TECHNICAL NOTE

Project: South Trowbridge
Ref: 0655/TN2.1
Client: Castlewood Properties Ventures Ltd.

This short Technical Note has been prepared to summarise the transport planning and highways work undertaken and submitted to date and to confirm the current position in transport and highways terms with regard to the latest planning proposals in respect of the above.

Planning application reference: 20/03641/OUT. Land south of White Horse Business Park, Trowbridge. Outline application for up to 100 dwellings and a care home (Class C2 Use) of up to 64 beds (up to 3,750 sqm), as well as vehicular access from the A363.

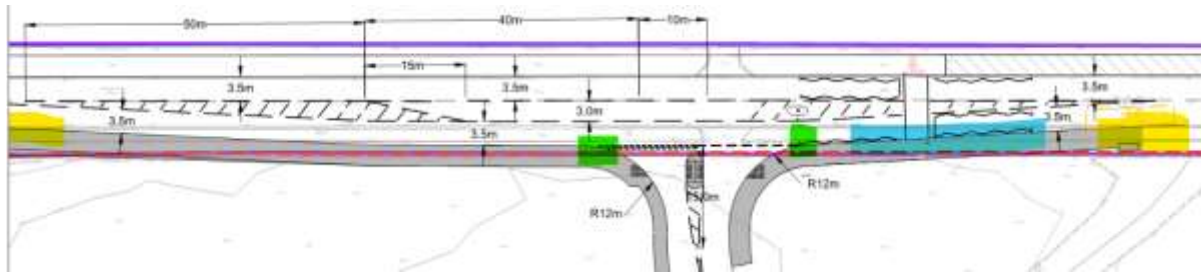
Junction Geometry & Layout

The taper on the west side of the junction (marked green) is now omitted in the latest revision – refer to extract below. Two 12m radii now take it back to the channel line shown green to the east of the junction.

There may appear to be a taper to the east (blue). However, this is not a taper on the junction but a taper on the GIRT, which is designed in accordance with DMRB.

The tapers in yellow have been introduced to tie-in with the A363 accordingly. Both junction and GIRT have been designed to DMRB.

Junction redesigned to WC highways amended lane width requirements.

Title
Swept Path Analysis

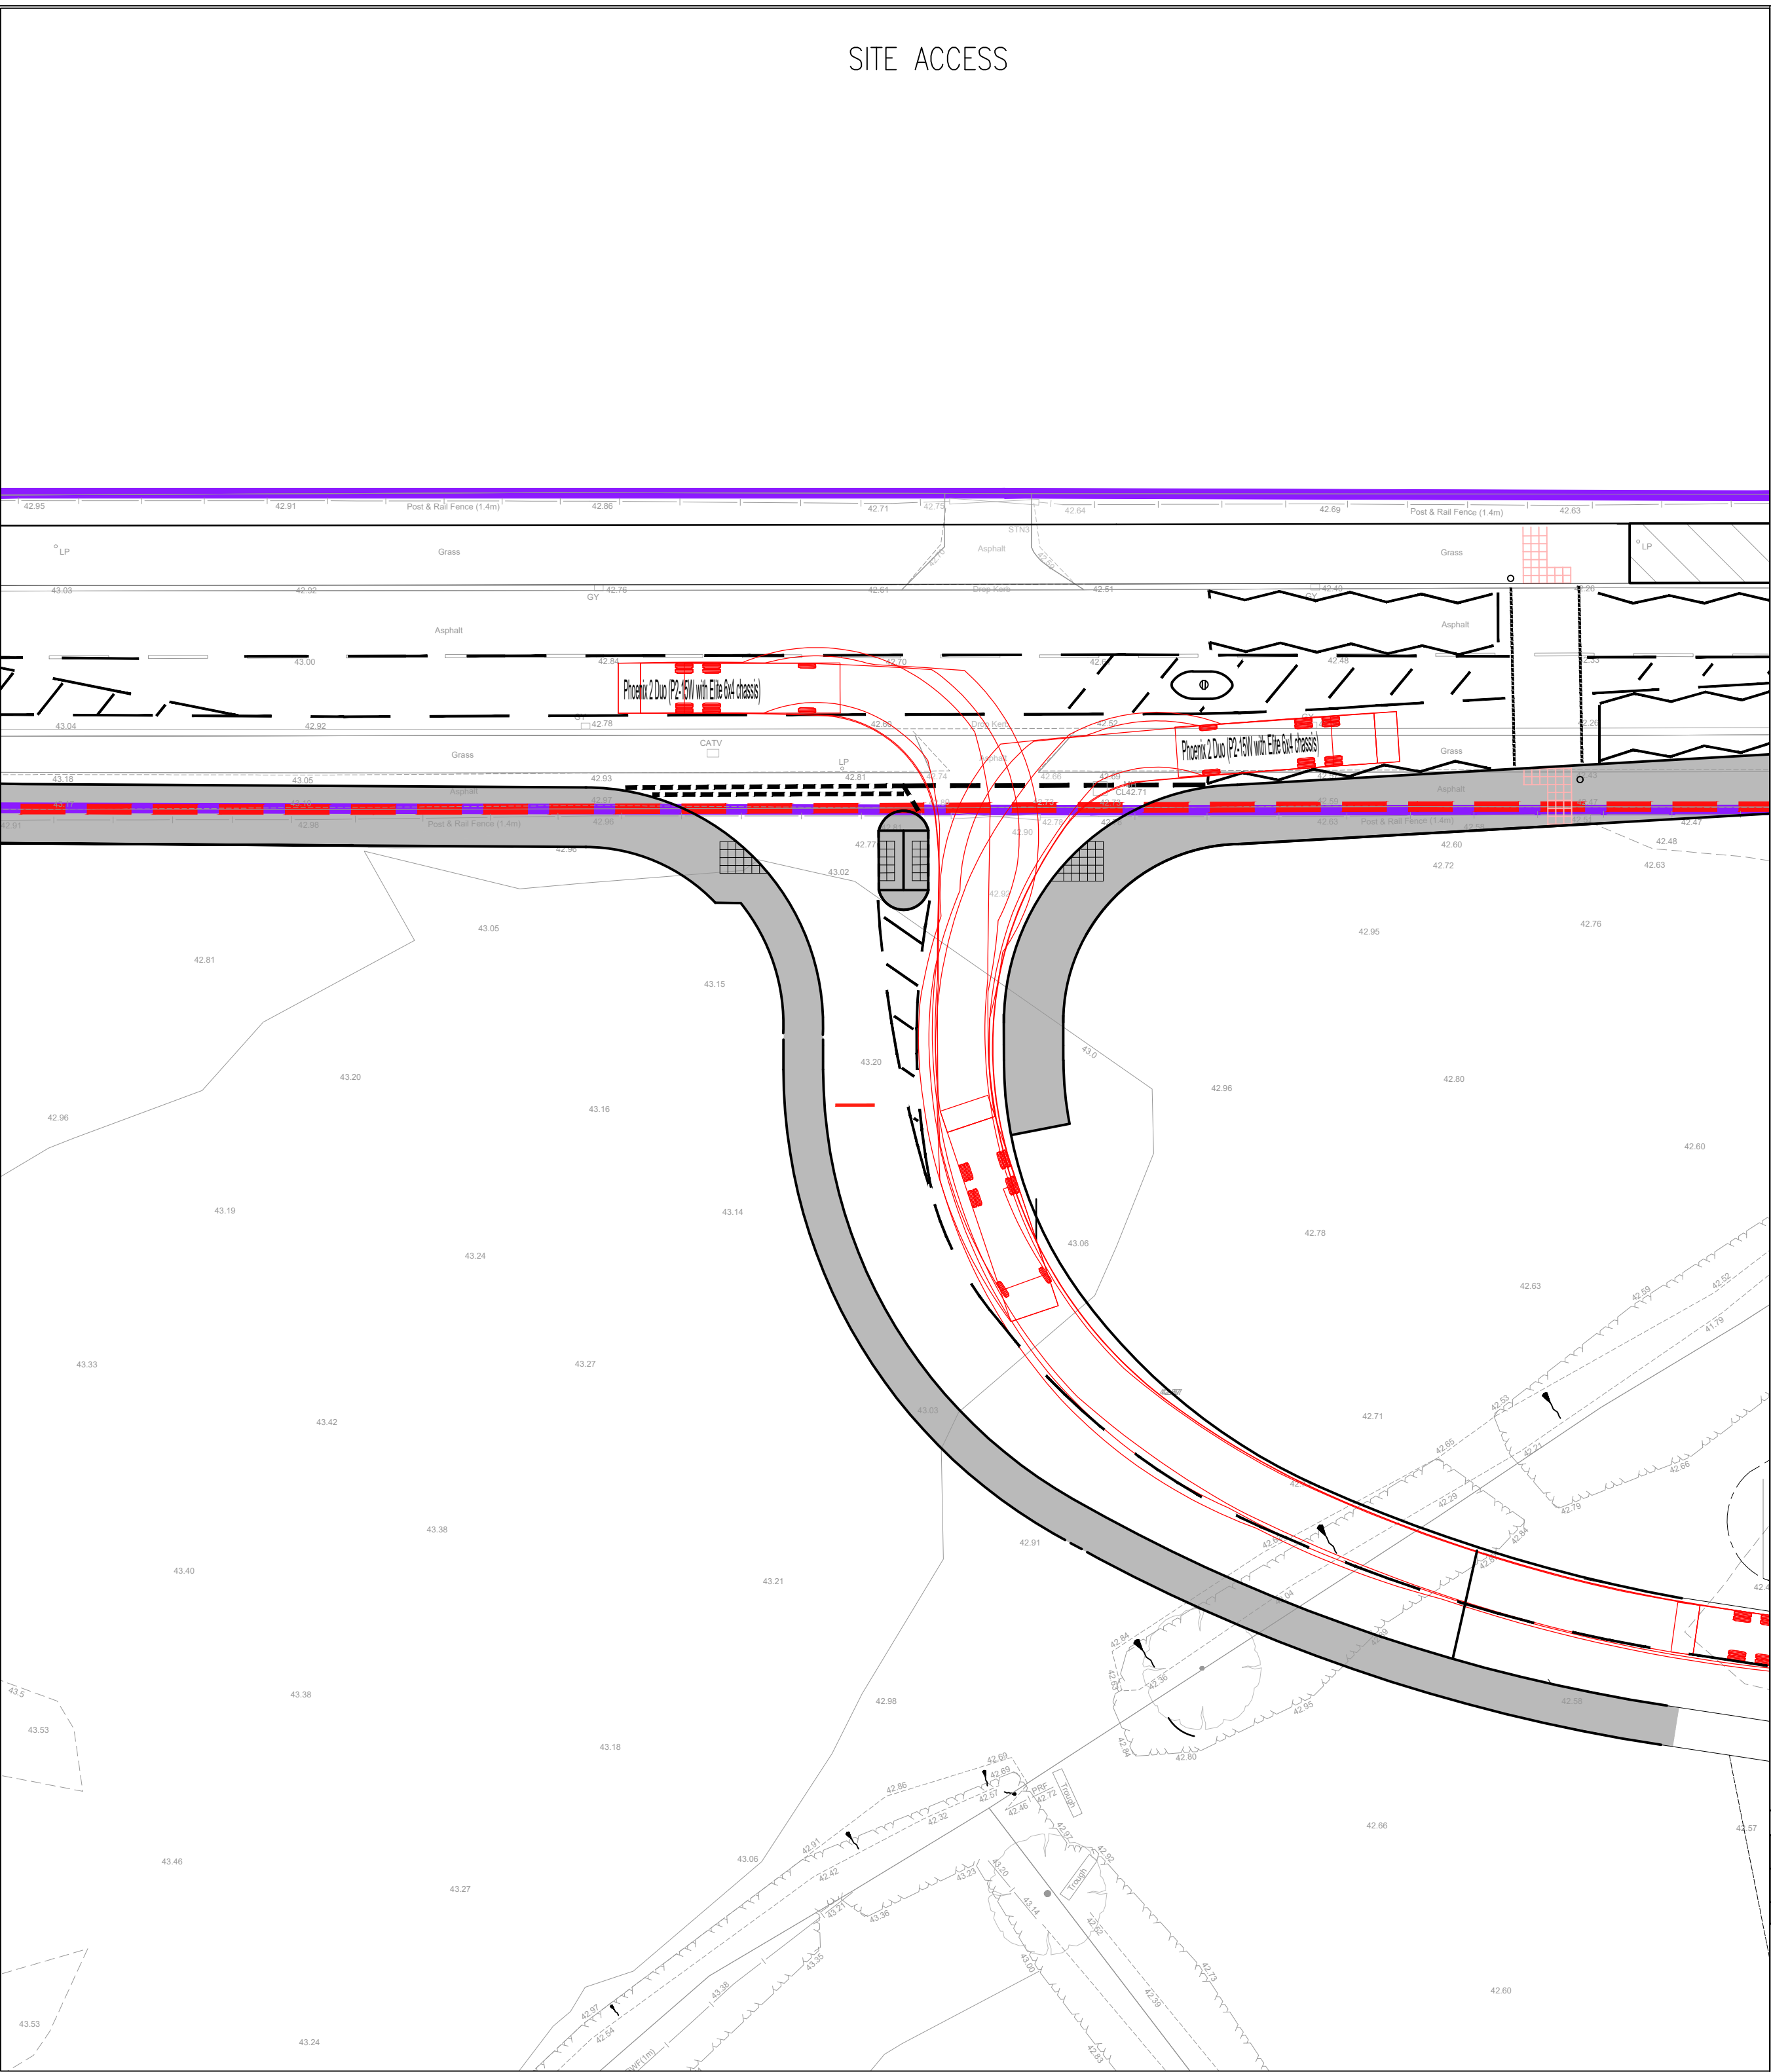
In any case, queues on the A363 will continue to extend across the proposed new access location and so corrupt the capacity assessment. If nothing else, it will require a yellow box to permit the right turn in. It will also be designing-in danger. Drivers wishing to turn right out of the development will at times have to turn right through a slow-moving queue with no visibility to the left to pick up traffic accelerating away from the roundabout. A detailed Road Safety Audit by someone spending time at the site, should pick this up. I would also like to see a tracking diagram for a long vehicle turning right and left in to the proposed site. The refuge seems too close to the A363.

Swept path for a refuse vehicle undertaken and attached (Drawing No. 0655/006/Rev.B).

Toucan crossing now provided and swept path for a refuse vehicle undertaken as request by the local highway authority.
